DAUPHIN COUNTY SUBDIVISION/LAND DEVELOPMENT REVIEW REPORT

Plat Title Overlands of William Betancourt Jr.

Project Description: To consolidate 3 adjoining lands of common ownership.

PRELIMINARY/FINAL MINOR SUBDIVISION PLAN

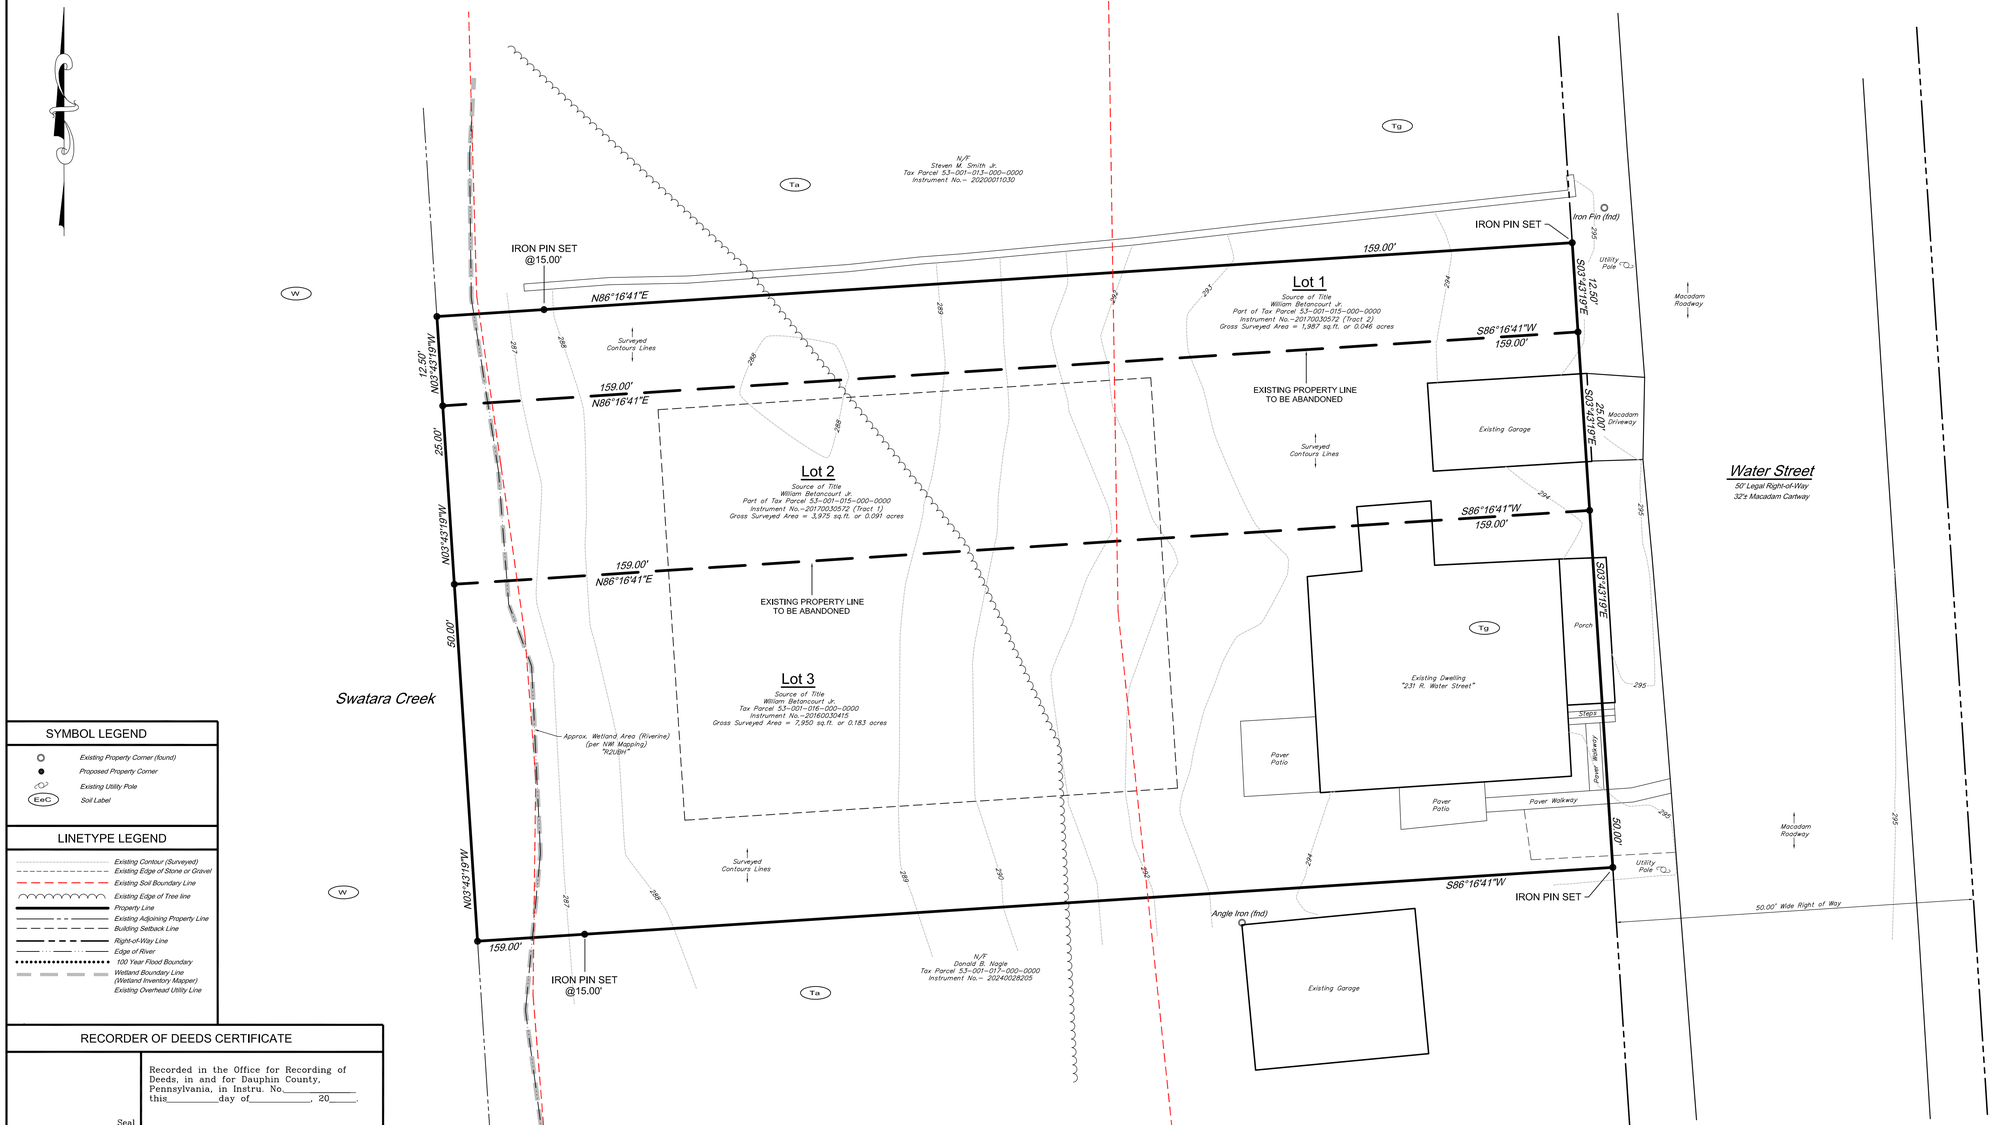
2. Label any existing or proposed easements or protective covenants, if applicable.

3. Sections 606 and 607 of the Subdivision and Land Development ordinance require the installation of curbs and sidewalks. If not provided, the applicant should request a waiver or deferral.

4. Verify that the width of the newly created lot is 50’ at the front building line in accordance with the standards established in the zoning ordinance (Article VI- “R-ST” Section C – Width Regulations.) and the impervious coverage percentage of the newly create lot (Article VI-“R-ST” Section C – Coverage Regulations).

5. Label yard/building setbacks (Article VI- “R-ST” Section C – Yard Regulations). As the existing development does not appear to comply with setback regulations, the Township should talk to their solicitor about making a note on an existing nonconformance or whether a zoning variance might be required moving forward.

6. Determine how Section 510 of the Subdivision and Land Development – Recreation and Open Space applies to the proposed lot.

7. It is noted that entirety of the lot is within the FEMA-designated floodplain. As a new lot is being created, the Township should determine what requirements of Ordinance 222 – Floodplain Management and other applicable regulations apply.

8. If Water Street is a state-owned street, verify that valid Highway Occupancy Permit (HOP) is on file.
